#### COUNTRY ESTATES EAST WATER AND SANITARY SEWER IMPROVEMENTS

#### Monroe Township Water & Sewer District October 3, 2016

#### **ADDENDUM #2**

#### LOW PRESSURE AIR TEST

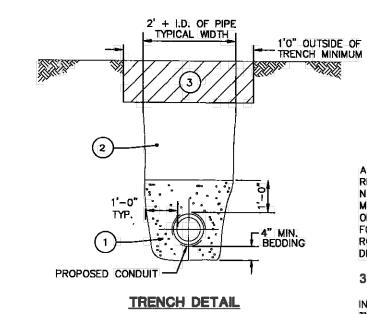
- Item 1: Attached find revised plan sheet 3 for the sanitary sewer improvements which revises some quantity irregularities and corrects the missing vacuum test time chart.

MH EX2 TO MH S4 & MH S2 TO MH S8

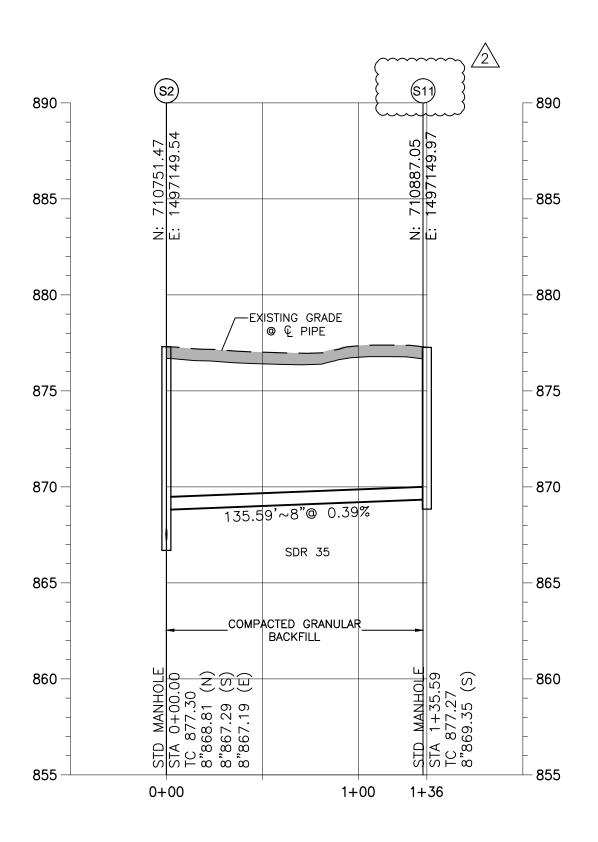
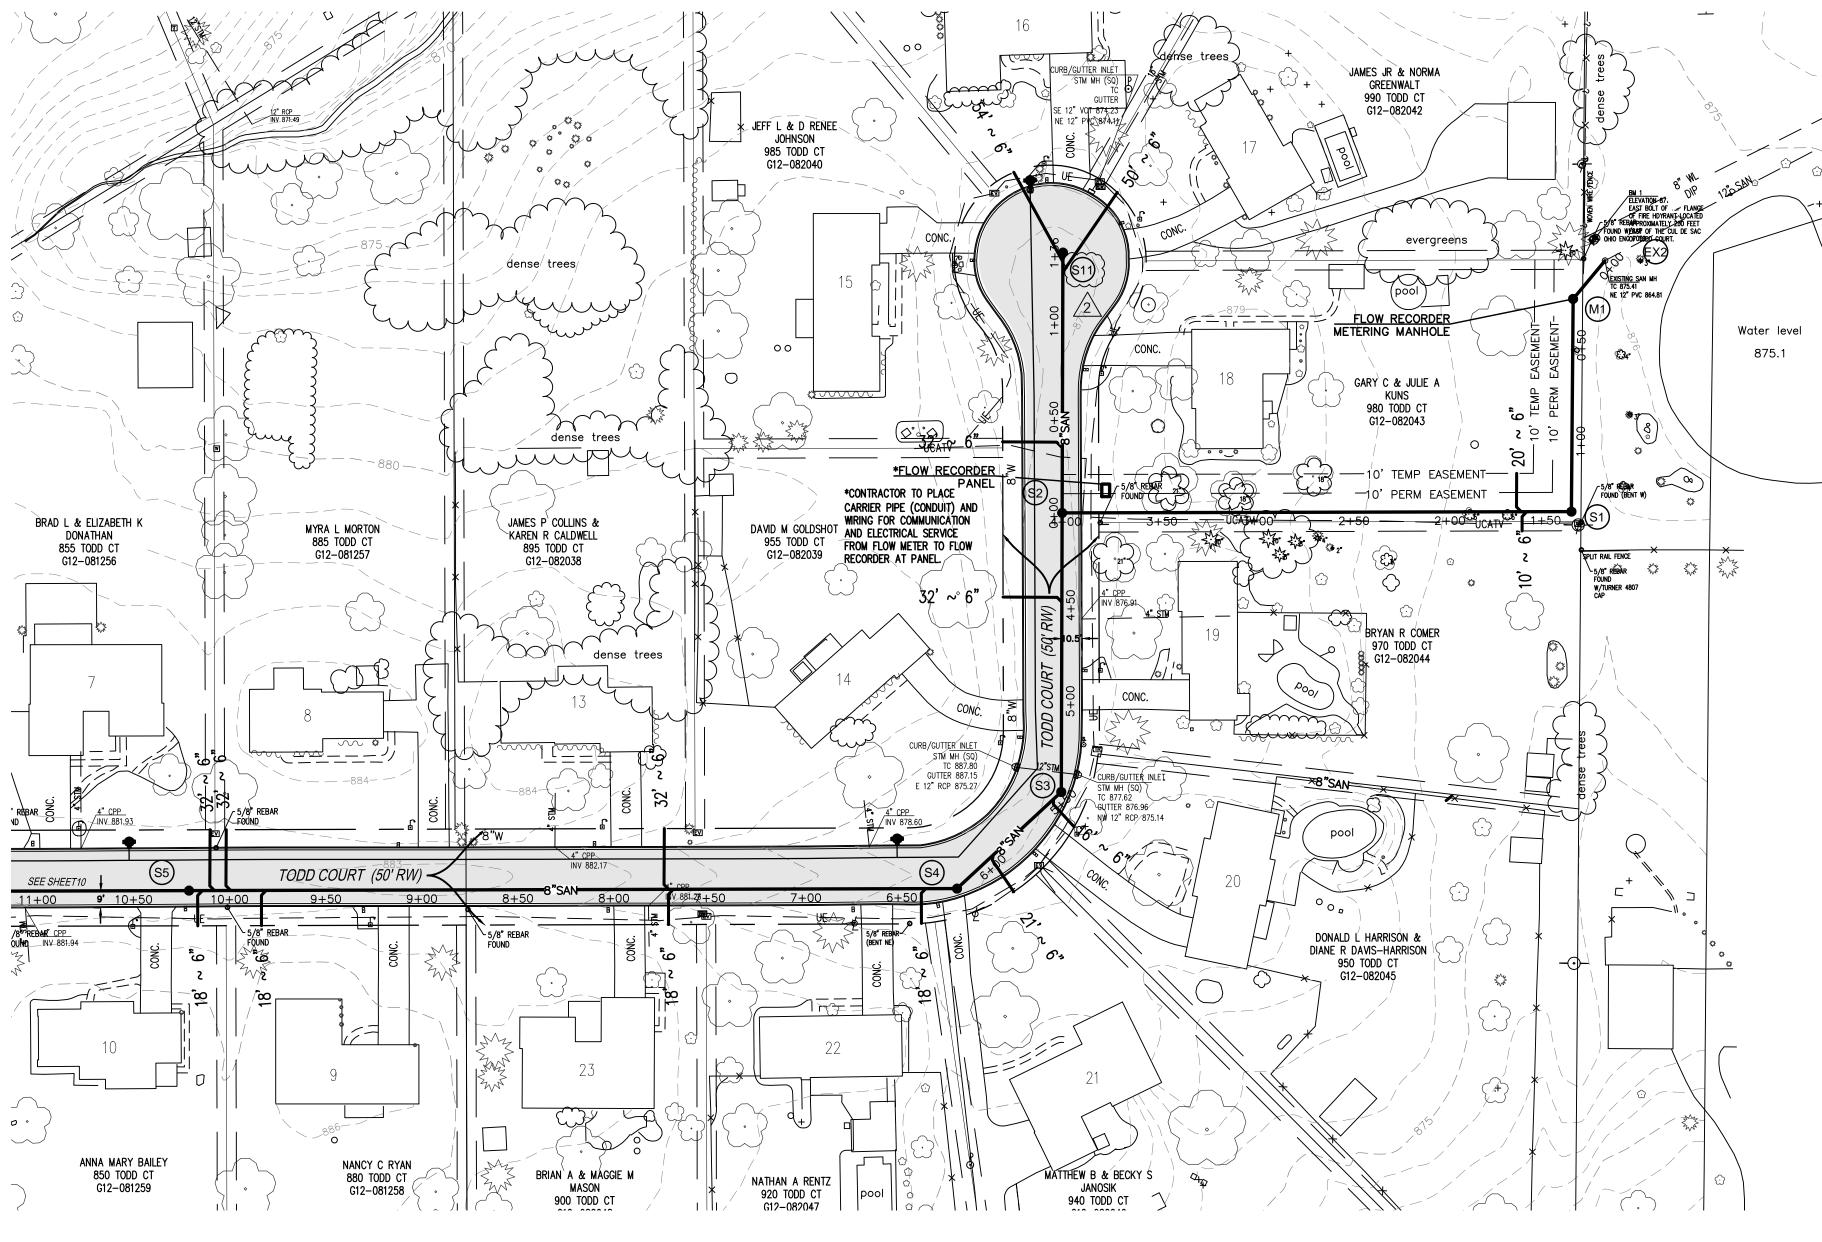
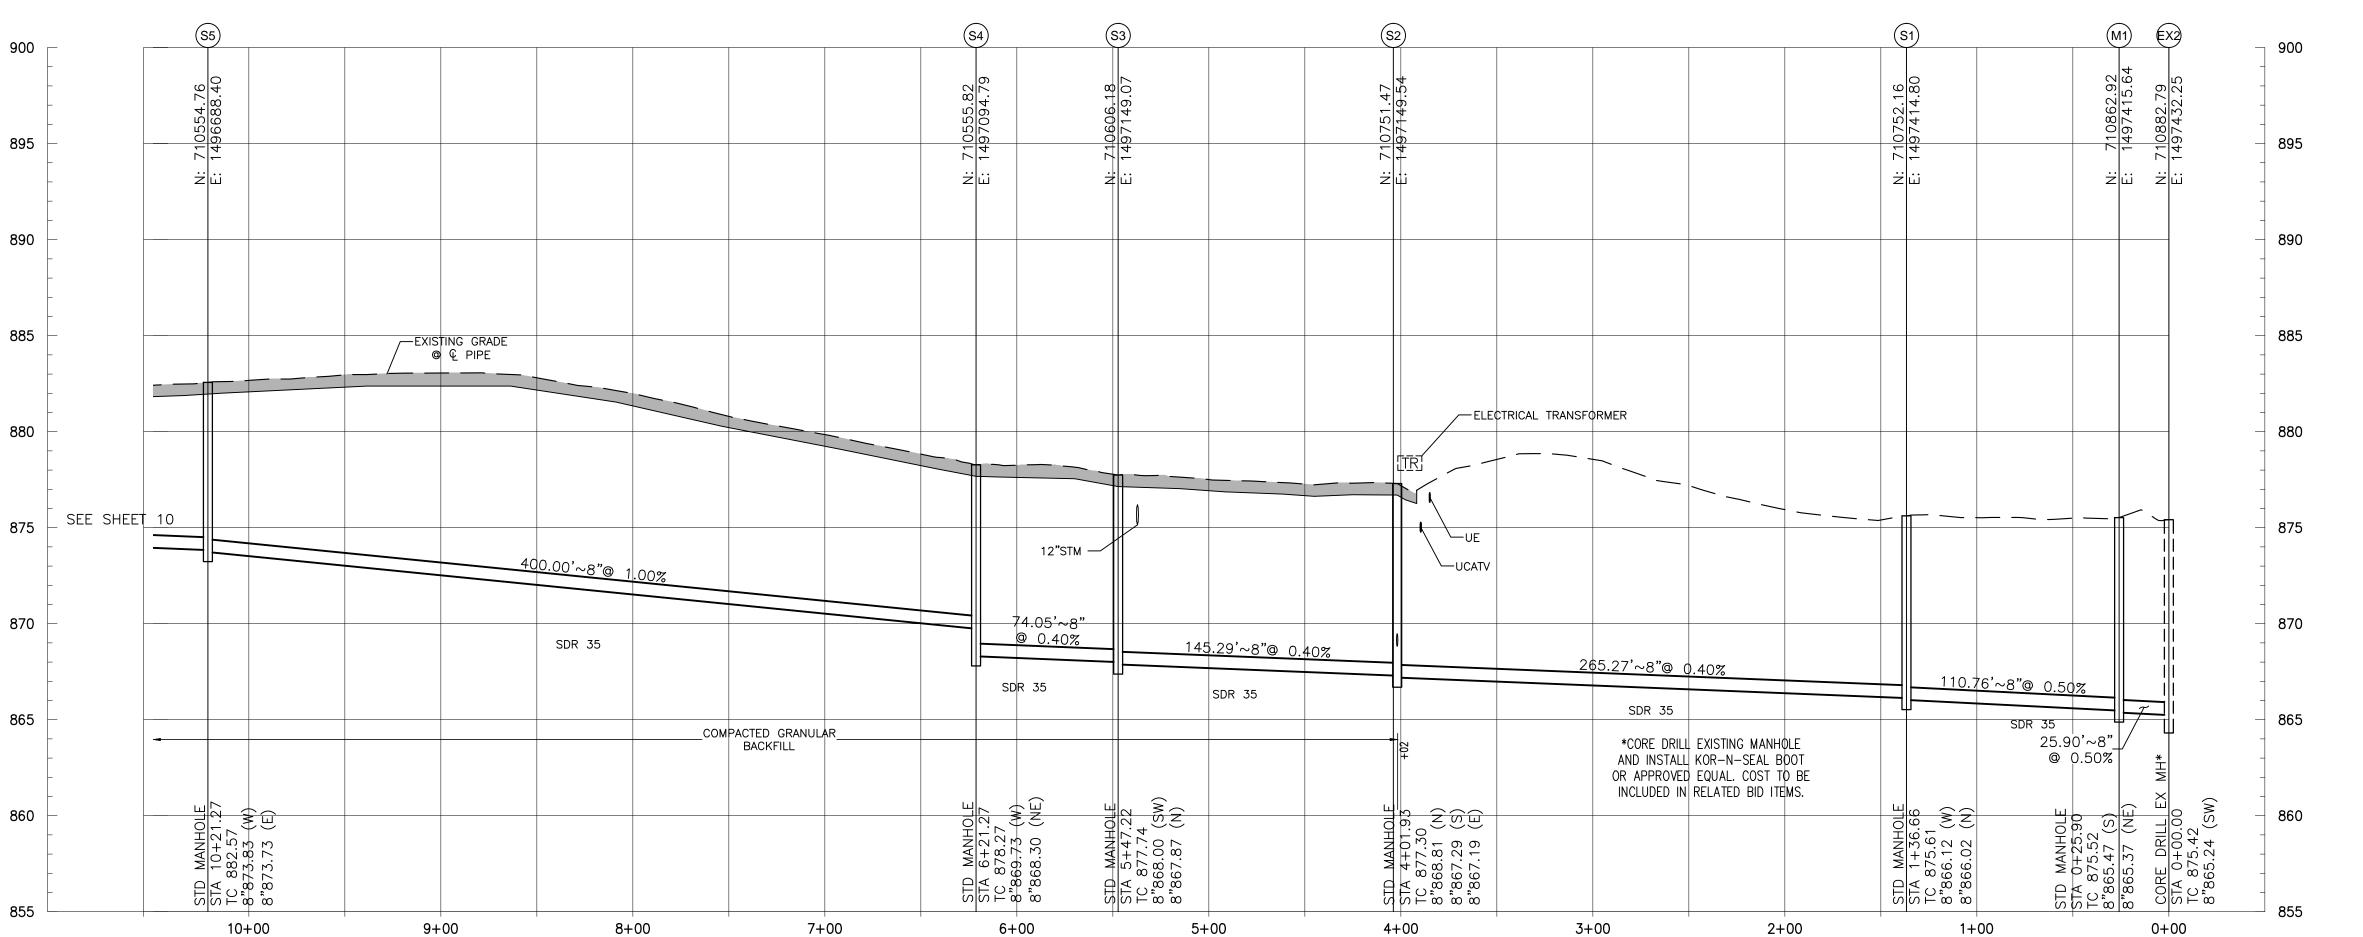
- Item 2: Attached find revised plan sheet 9 for the sanitary sewer improvements which corrects the manhole callout for manhole S11.
- Item 3: Attached is revised sheet 4 for the waterline improvements which revises some quantity irregularities.

3/4", 1", & 2" STANDARD WATER
SERVICE W/ METER BOX
NOT TO SCALE

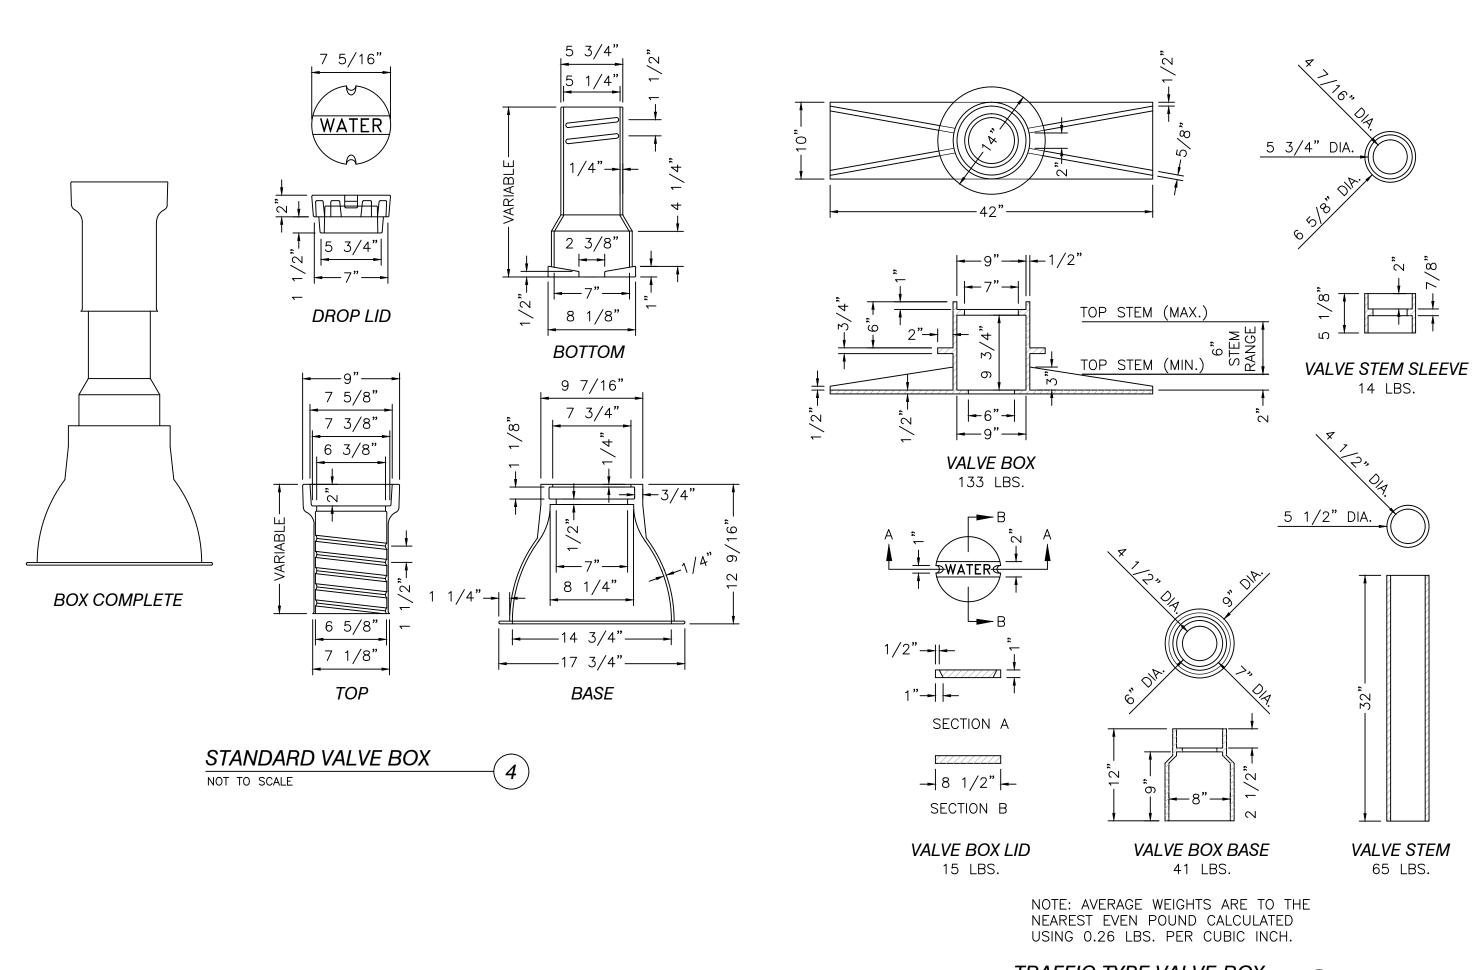
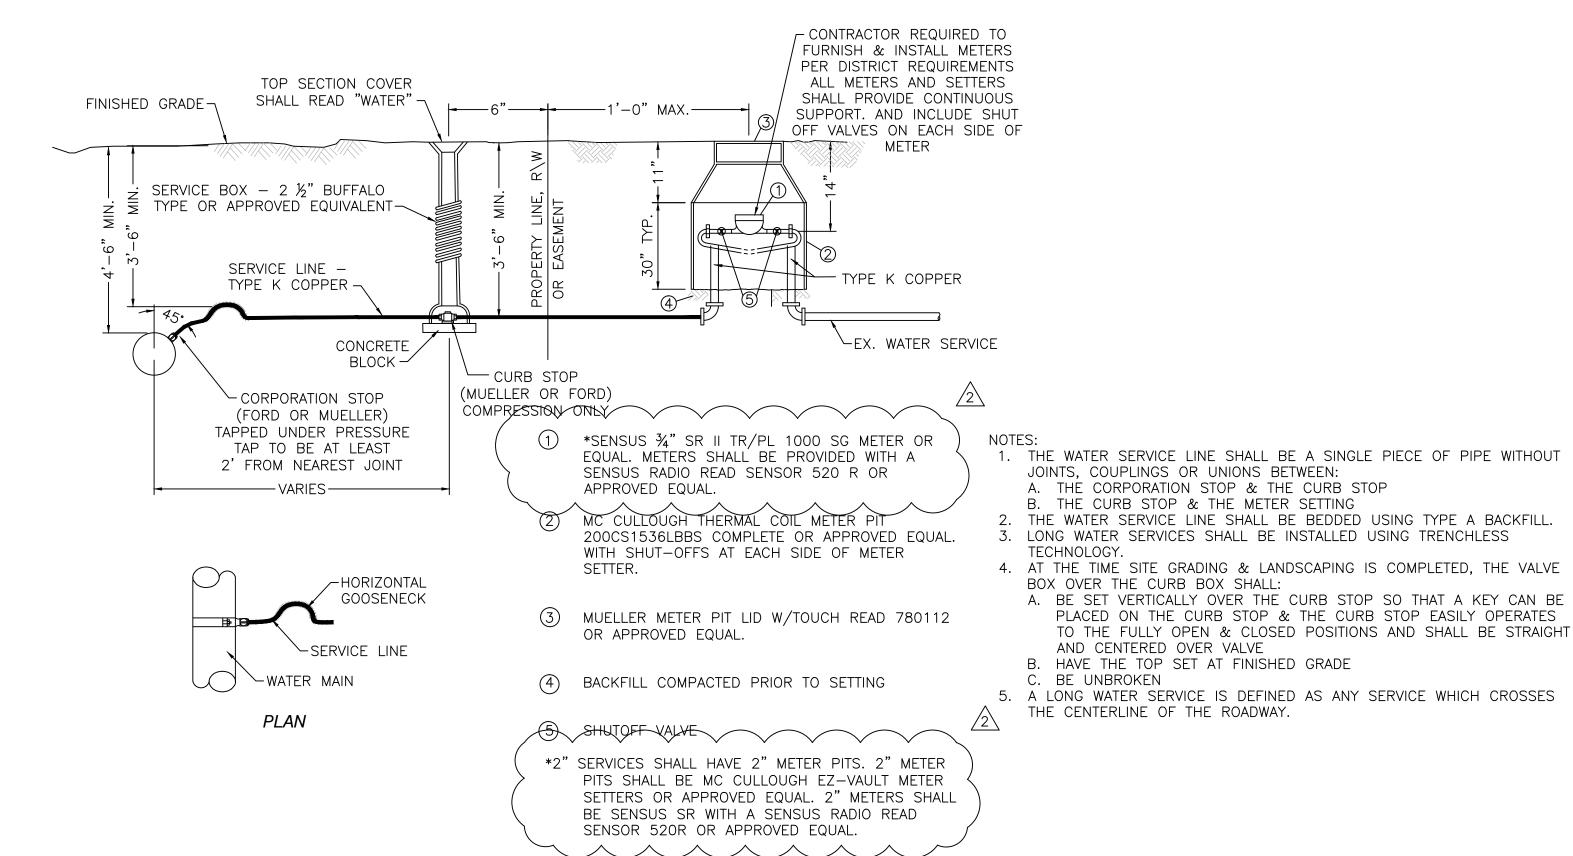
- Item 4: Attached is revised sheet 5 for the waterline improvements which revises the water service detail to include 2" water services and clarifies meter sizes.

3/4" service will require 3/4" meters and 2" services will require 2" meters. See attached revised sheet 5 for clarifications as to the meter pit type to be used for 2" services.
- 9. What type of chimney seals are to be used?
  All manholes will require an internal chimney seal be installed between the casting and concrete manhole. Chimney seal shall be as manufactured by CRETEX or an approved equal.
- 10. Waterline appears to be close to the curb face averaging 14-26" of asphalt once trench is cut and excavated. If this doesn't hold up will the contractor be paid for replacing this asphalt?
